# ***Environmental Impact Statement***

## **ADDENDA NO. 01**

### ***N4 Collooney to Castlebaldwin Proposed Road Development***

Figure No.:  
Fig.: 4.1.1  
Sheet 1 of 8

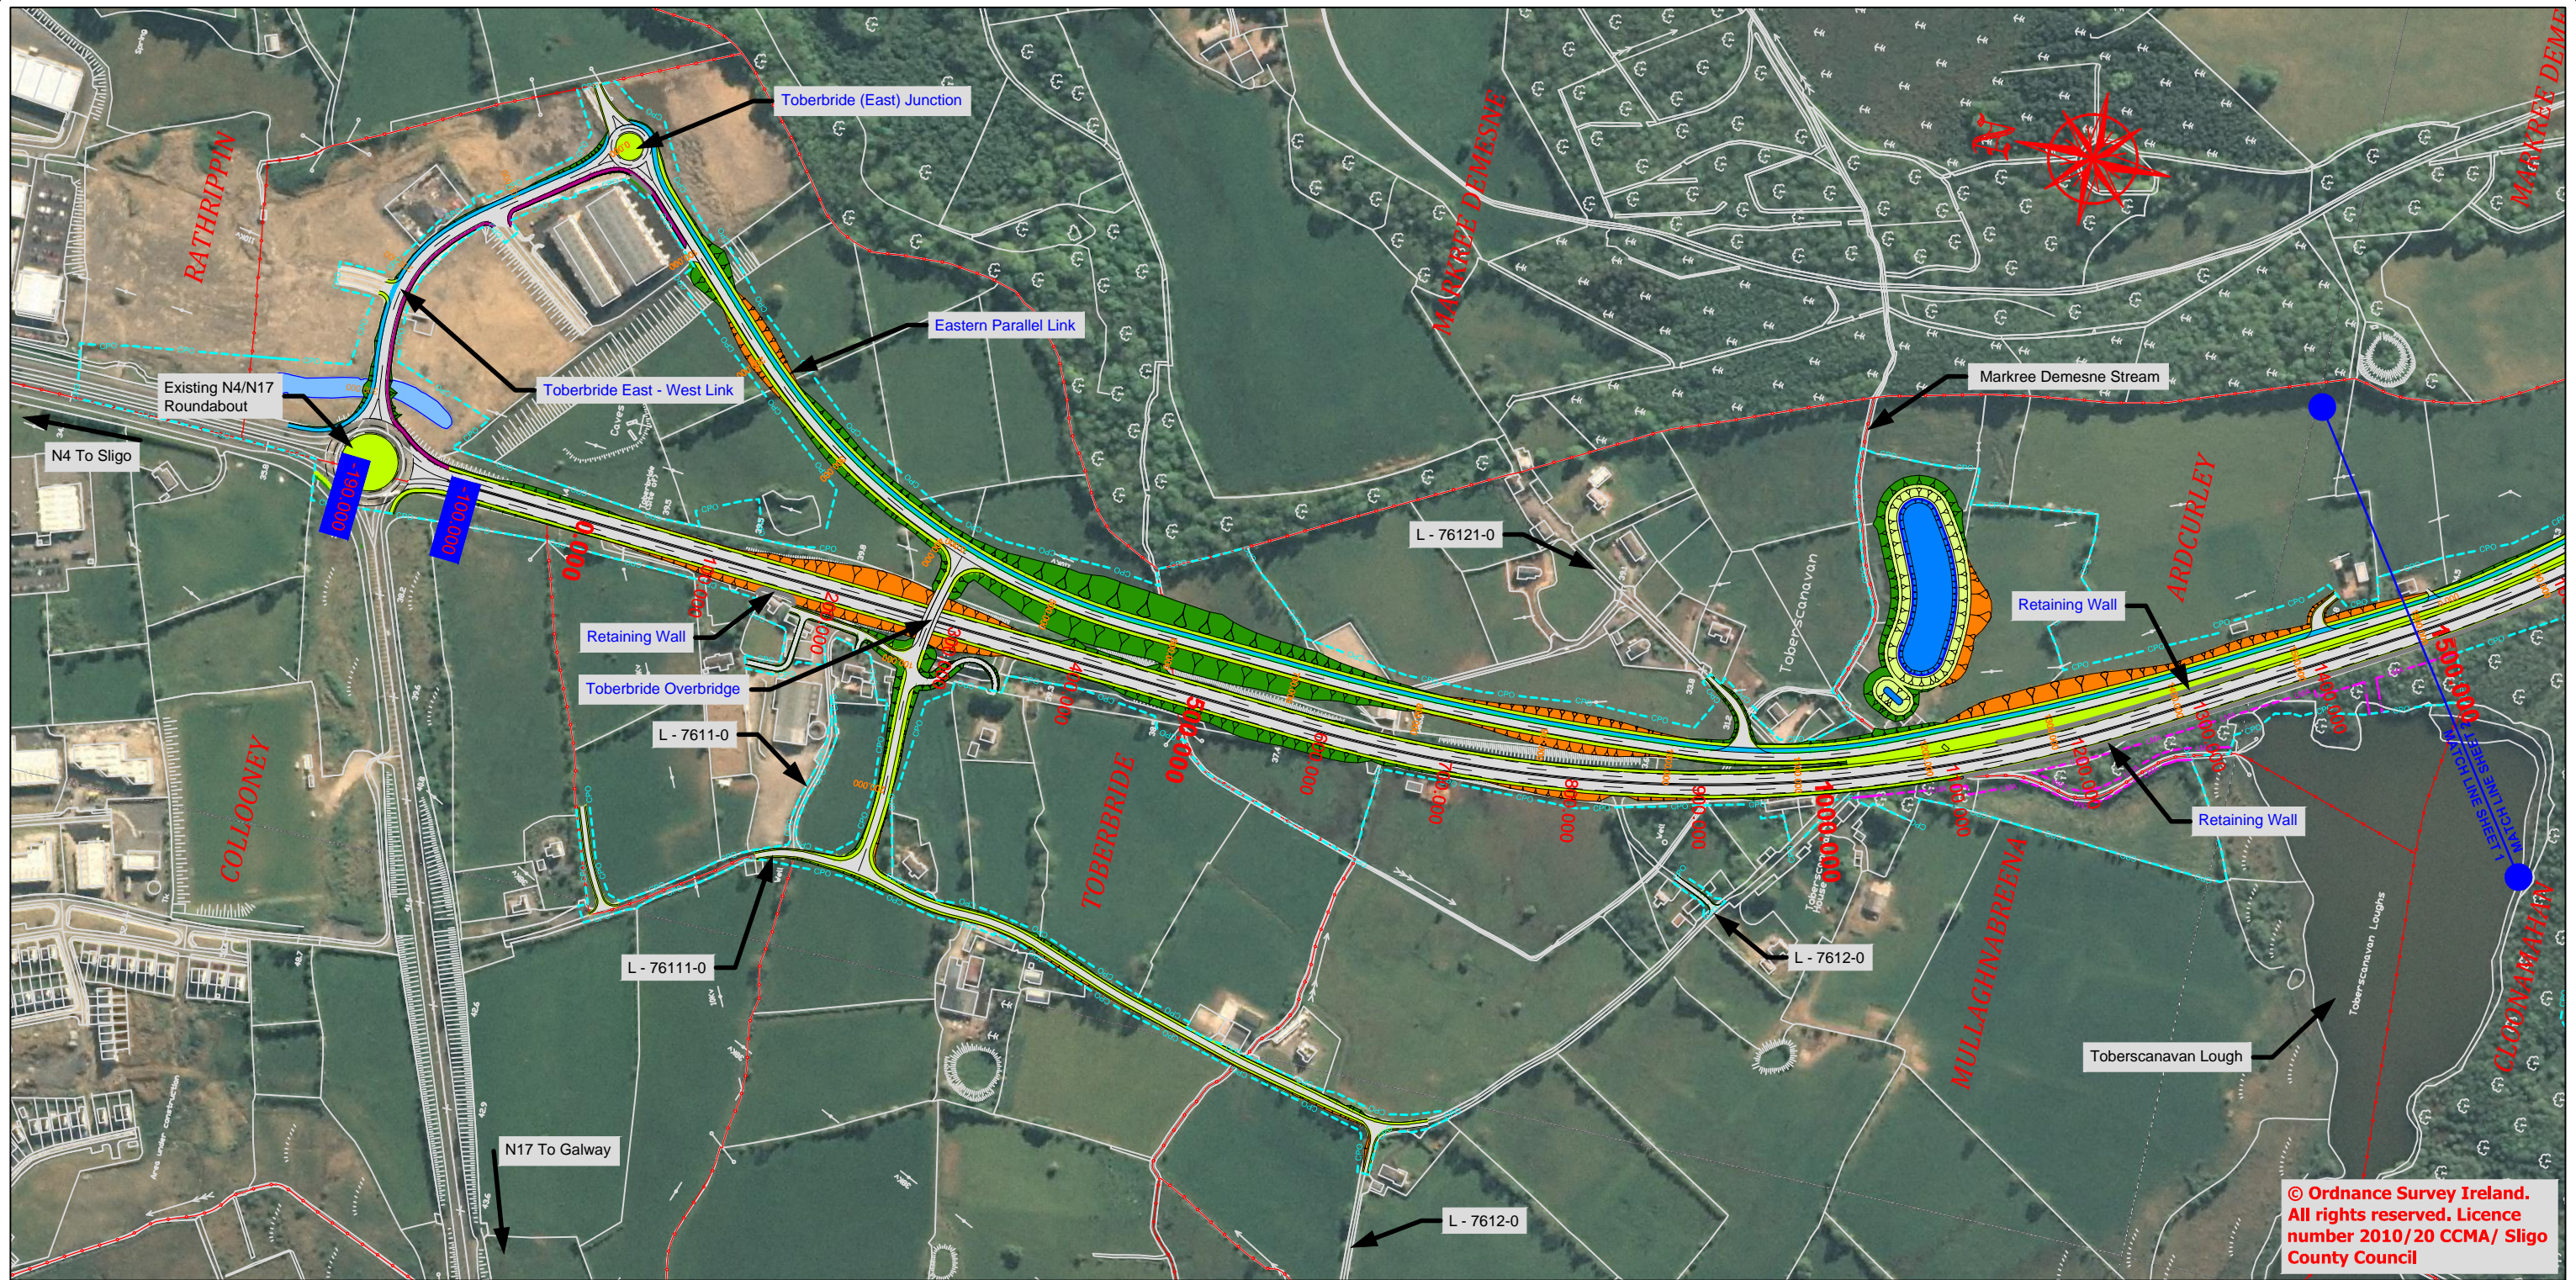
#### **Figure 4.1.1**

A farm access track is added to the north of the Toberbride (East) junction. For brevity this addition is not repeated throughout other drawings in the EIS.

| Date       | By | Revision  |
|------------|----|---|
| April 2014 | FM | This is an addenda to the EIS as described in Addenda Sheet No. 01.               |
|            |    | A farm access link has been added to the north of the Toberbride (East) Junction. |

Figure No.:  
Fig.: 4.1.8  
Sheet 8 of 8

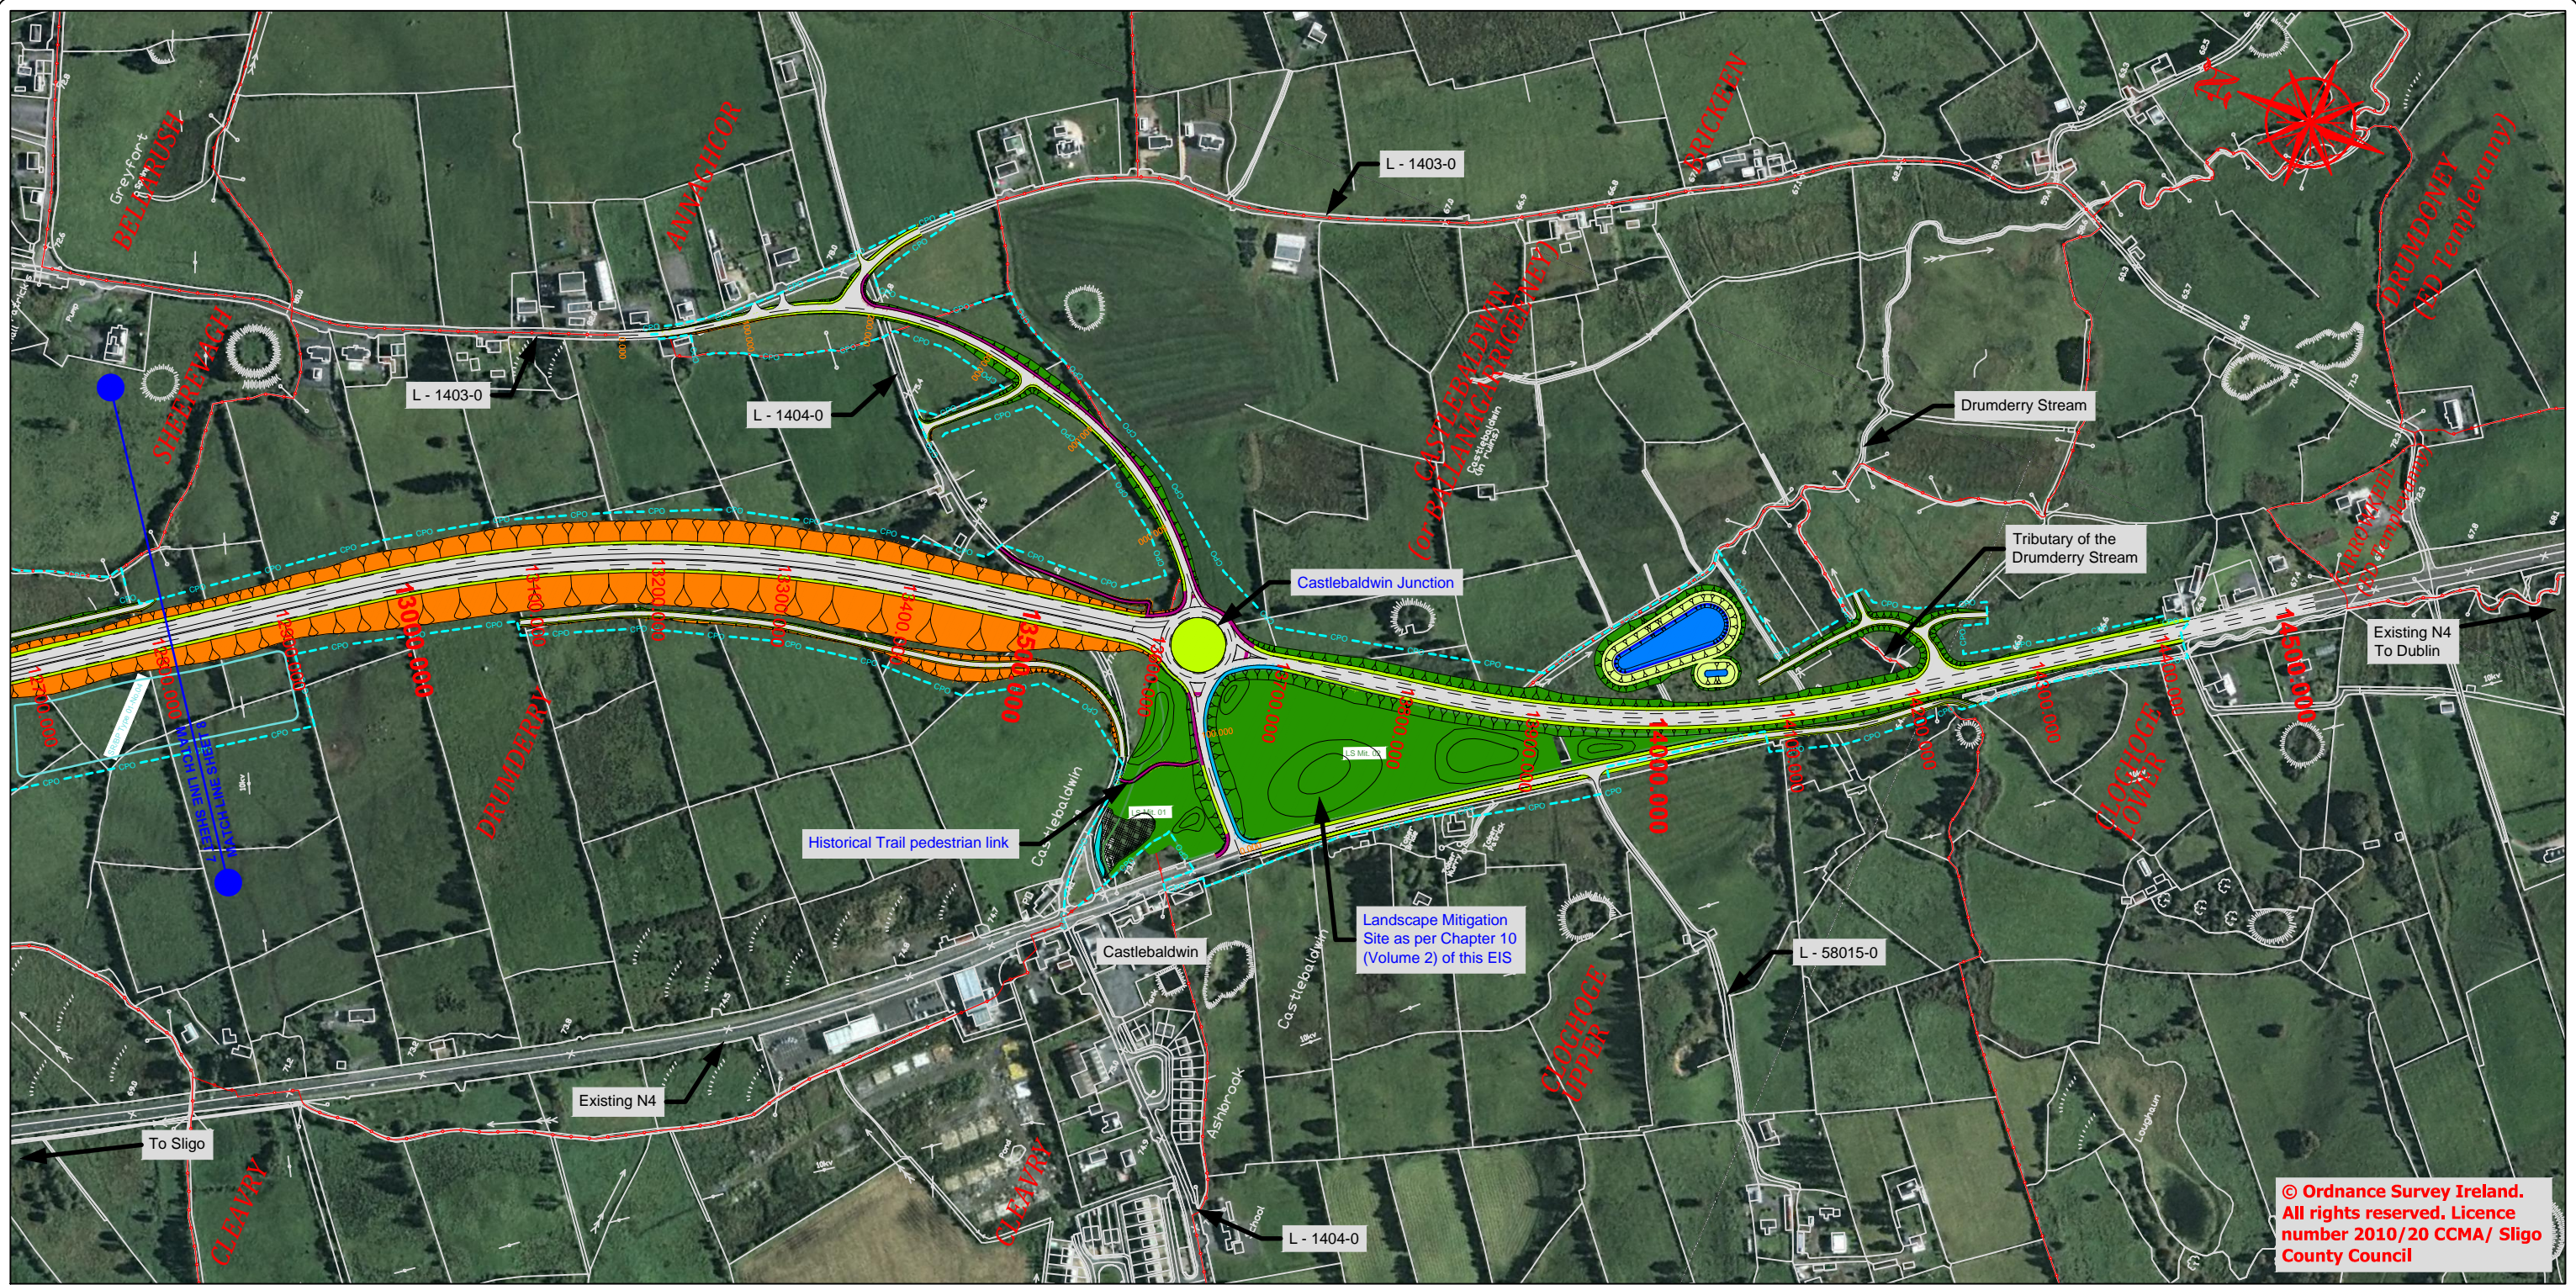
#### **Figure 4.1.8 and 4.10**

The pedestrian trail is re-linked to provide the uncontrolled crossing on the Standard Single Carriageway section (at a refuge island) of the proposed N4 as opposed to the Type 2 Dual Carriageway. This will shorten the time to travel across live carriageways on the national network.

| Date       | By | Revision  |
|------------|----|---|
| April 2014 | FM | This is an addenda to the EIS as described in Addenda Sheet No. 01.   |
|            |    | The historical trail pedestrian link has been re-linked to provide the uncontrolled crossing on the Standard Single Carriageway section of the proposed N4. |

| <b>Title</b><br>EIS, Chapter 10 Drawings: Landscape and Visual Impact Assessment |                                 |                             |

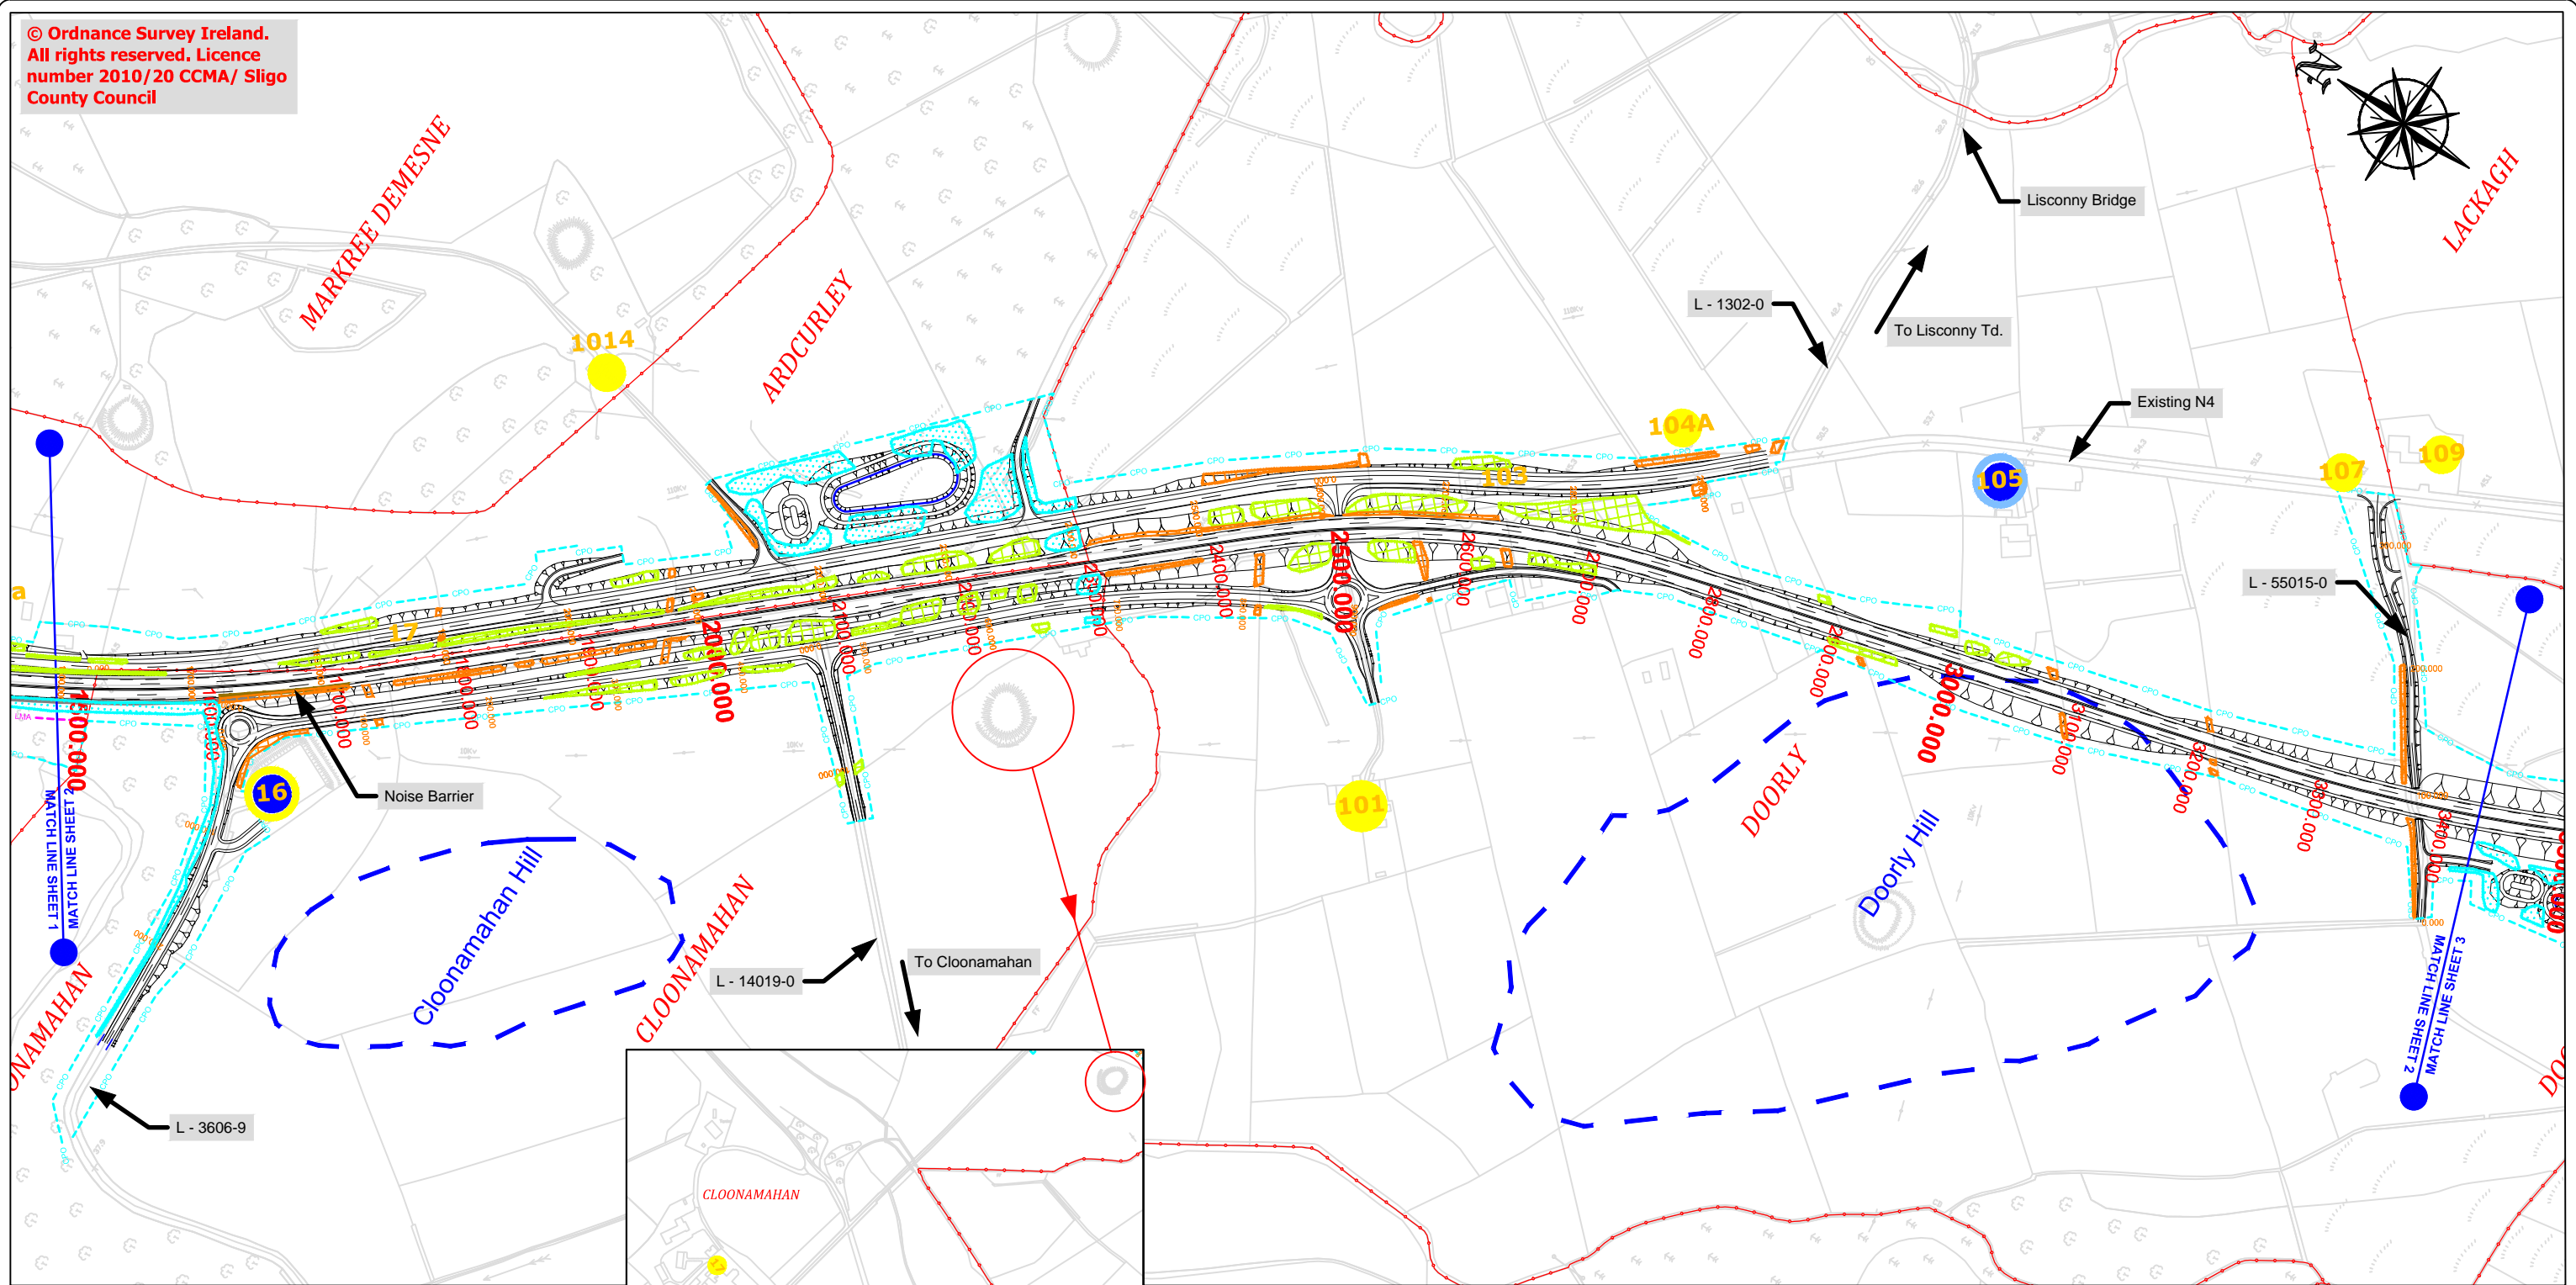
| Date       | By    | Revision  |
|------------|-------|---|
| April 2014 | FM/CW | This is an addenda to the EIS as described in Addenda Sheet No. 01.                         |
|            |       | Based on submissions received, an additional receptor is added north-east of c. Ch. 1,950m. |
